# Corrigendum 2 to IEC 61000-4-4 ed. 2; 2004

## How to calibrate the transient waveform at the output of the CDN

Authors: H. Kunkel, Member of TC77B MT12, EM TEST Switzerland  
M. Fuhrer, Application Engineer, EM TEST Switzerland

Fig. 1 Measuring setup as per Corrigendum

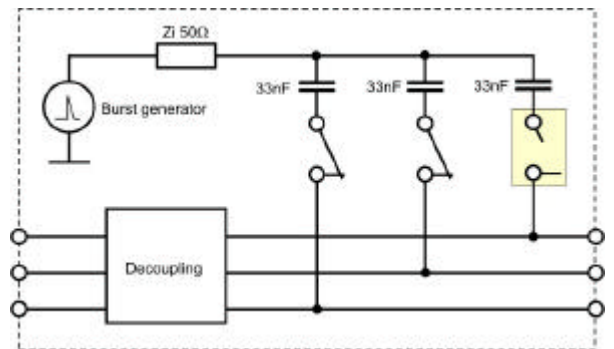
- A short circuit at the output of the CDN, the above figure shows a 3 phase CDN, does not rely on the real test situation in the field. In reality this would lead to a short circuit in the power supply mains.
  - Normally the transients shall be measured in the same configuration as it used for testing (without short circuit).
  - The safety problem for the operator, to make a short circuit across power mains output sockets, is not further discussed in here.
- In the above shown configuration, using a short circuit across the CDN output, all lines will be tied together and measured together.
  - It is false to believe that, if all lines tied together and measured across the 50Ω termination are within the specified tolerance range, also each individual line is working correctly.

- This failure **can not** be detected by using the short circuit across all CDN output. The correct working coupling paths will dominate the measurement, see table 2.

- The EFT transients are coupled to all lines of the CDN simultaneously.
- **The output of the CDN shall not be short circuited.**
- **The EFT transients shall be measured at each individual output of the CDN.**
- **Each individual output must show the transients within the tolerances as specified.**

➔ **Example 2: Coupling capacitor defect** (realistic failure occurring in a CDN)

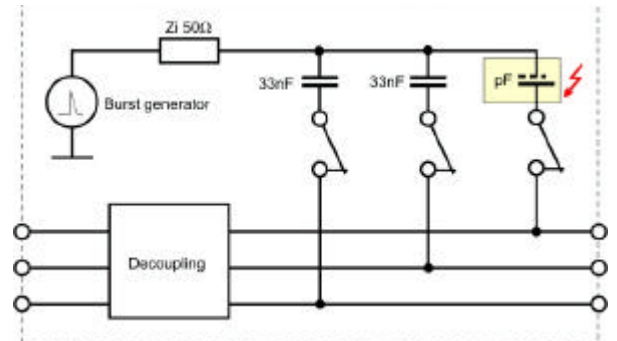
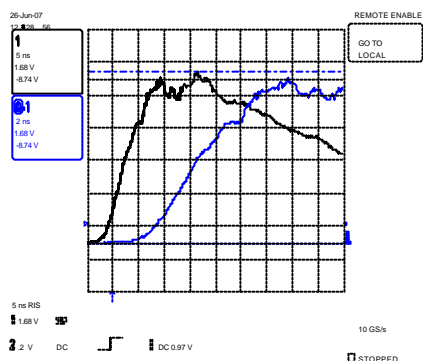
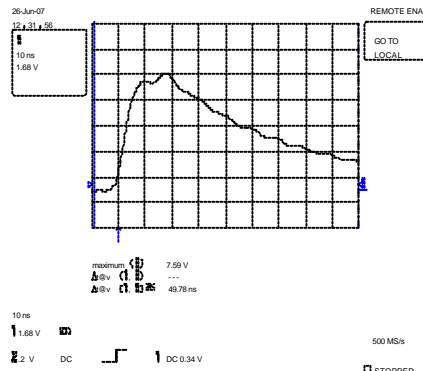
The coupling capacitor of 33nF in one coupling path (e.g. L) is damaged. The capacitor no longer has 33nF but is significantly smaller e.g. 33pF (internally broken).

- This failure **can not** be detected by using the short circuit across all CDN output. The correct working coupling paths will dominate the measurement (see table 3)

Output	Upeak	tr ns	td ns	Remark
L+N+PE	4040	5.14	45.1	Short circuit across the output. <b>Wave shape in tolerance!</b>
L only	<b>3496</b>	<b>7.68</b>	47.8	 <p><b>Coupling capacitor is partially broken.</b></p>
L only	<b>3096</b>	<b>8.38</b>	49.78	 <p>After some testing time the capacitor is completely damaged. <b>The EFT waveshape is completely distorted!!</b></p>

- ➔ For this case the standard tells you to check the function of each individual line additionally. This means that each individual output must be measured, additionally to the measurement across the short circuited output !!!!!

➔ **Example 3: Coupling capacitor wrong value** (realistic failure occurring in a CDN)

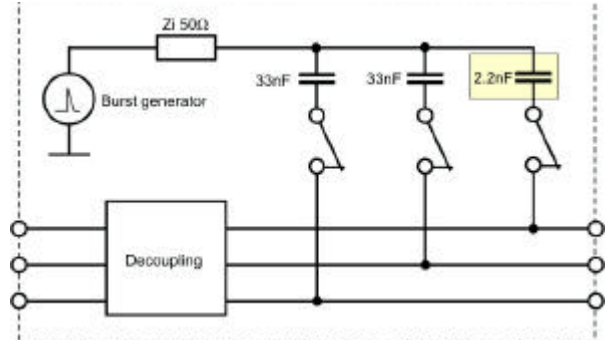
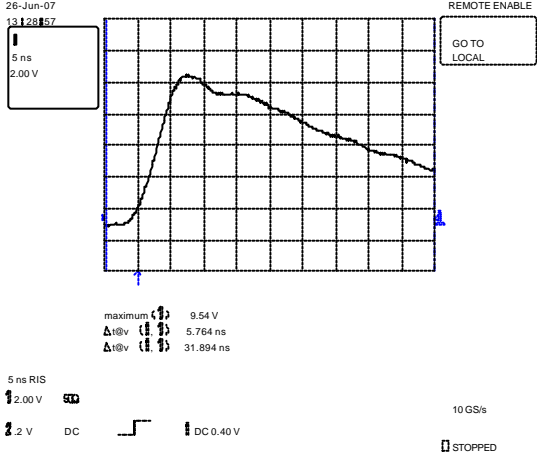
The coupling capacitor in one coupling path (e.g. L) has the wrong value,  $C_c = 2.2\text{nF}$ . Might be a failure in manufacturing.

- This failure **can not** be detected by using the short circuit across all CDN output. The correct working coupling paths will dominate the measurement (see table 4).

Output	Upeak	tr ns	td ns	Remark
L+N+PE	4016	5.57	45.57	Short circuit across the output. <b>Wave shape in tolerance!</b>
L only	3816	5.76	<b>31.89</b>	 <p>The test level is reduced and the pulse duration is out of tolerance.</p>

- ➔ For this case the standard tells you to check the function of each individual line additionally. This means that each individual output must be measured, additionally to the measurement across the short circuited output !!!!!

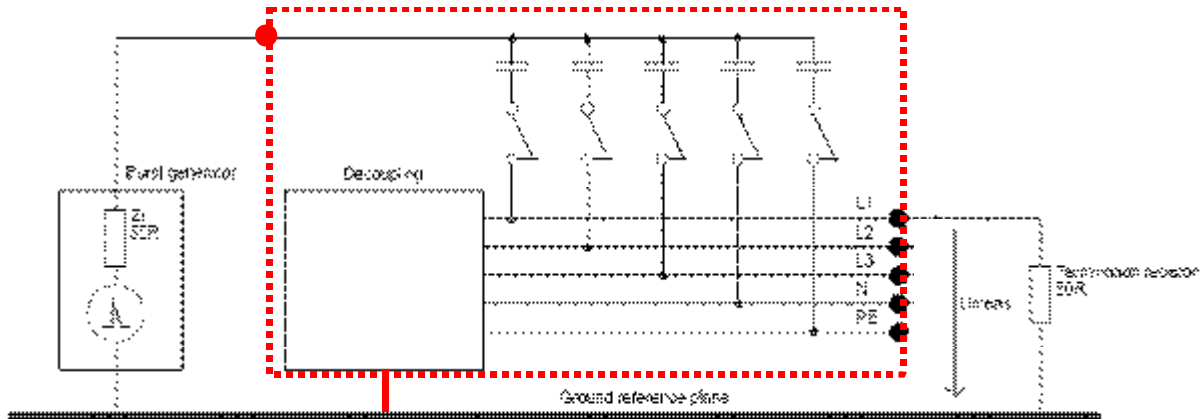
- EFT/ burst generators calibrated according to the actual corrigendum 2, using the “short circuit measuring setup” can be called conform to the standard. Anyway it can not be guaranteed that all coupling paths of the CDN are working properly. Lets stay with our coupling problems with L. This line will definitely not deliver the EFT transient as specified in IEC 61000-4-4
- In case of a 3phasen CDN the following applications are possible:
  - Coupling to 5 lines in a 3phase star system
  - Coupling to 4 lines in a 3phase delta system with neutral.
  - Coupling to 3 lines in a 1ph or 3phase delta-system without neutral.
  - Coupling to 2 lines in a DC power supply.
  - Coupling to a ground wire.

Because it is technically clear the „short circuit“ method does not allow the user or the lab to decide whether the generator and its CDN works properly all above shown application cases must be calibrated individually what finally again results in a measurement of each individual line.
